DEPARTMENT OF TRANSPORTATION**Federal Aviation Administration****14 CFR Part 36**

[Docket No. FAA-2000-7958; Amendment No. 36-25]

Noise Certification Regulations for Helicopters

ACTION: Final rule.

Figure H1.
Comparison of Measured and Reference Takeoff Profiles

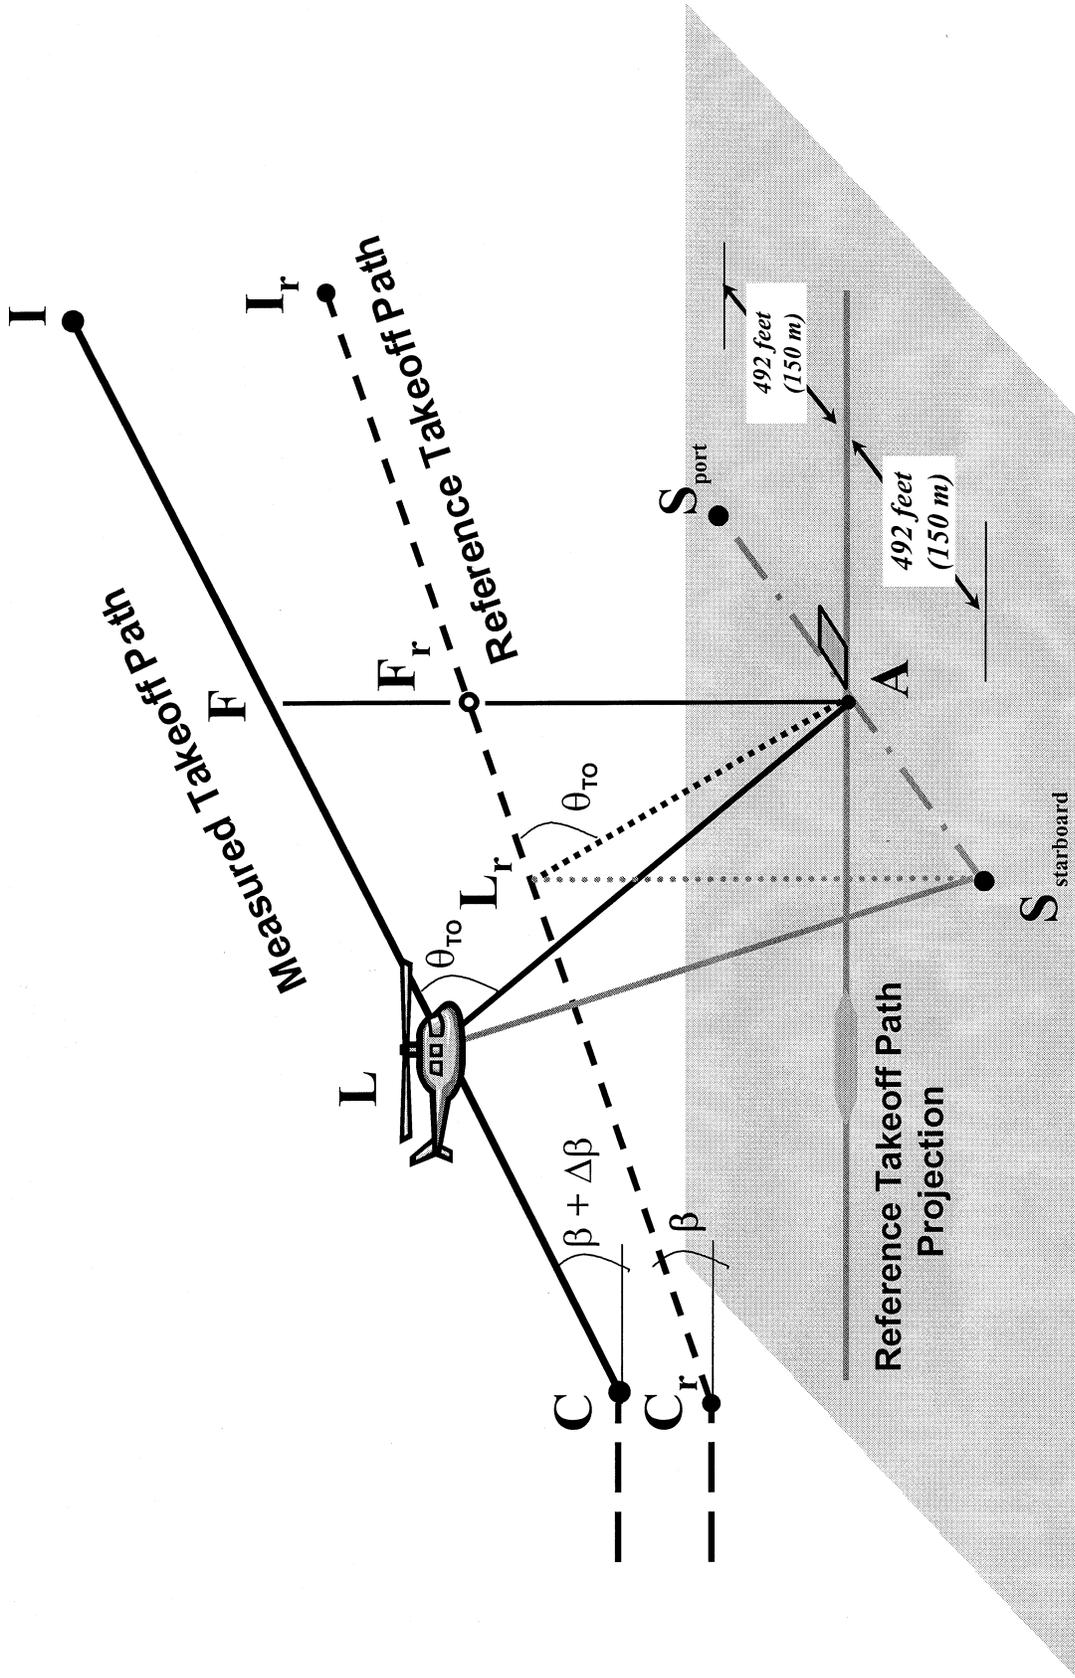
In Notice No. 00-12, the FAA proposed to revise Figures H1 and H3 to include the height above measurement points in metric units and to delete the closest point of approach (CPA) distance designations. The FAA received no comments on this proposal and it is being adopted as proposed.

Although Figure H2 changes were not addressed in the NPRM, for accuracy and completeness, the FAA is making corrections to typographical errors and replacing incomplete designations. The word "corrected" is replaced with the

word "reference" in the titles of Figures H1, H2 and H3 in the final rule. This change keeps the language in the final rule consistent throughout Appendix H.
